DEVELOPMENT MANAGEMENT AGENDA

DEVELOPMENT MANAGEMENT COMMITTEE

ADDENDUM SHEET

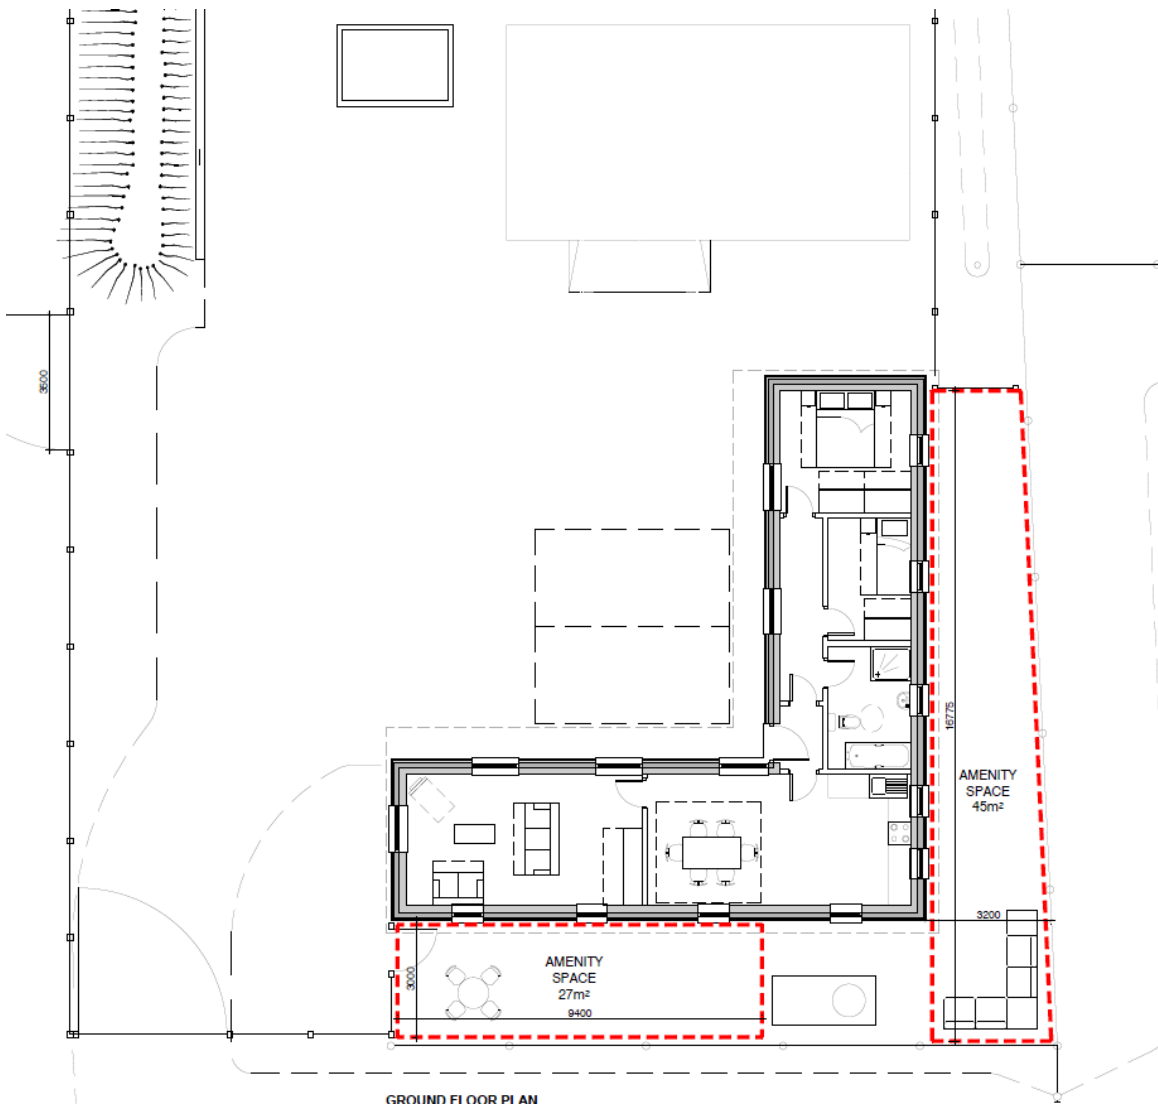
The agent has submitted two additional plans, indicating the proposed amenity space arrangements and proposed provision for electric vehicles:

- 1) Proposed Ground Floor Site Plan – Amenity (Reference 1094-G11)
- 2) Proposed Site Plan – Electric Vehicles (Reference 1094-G12).
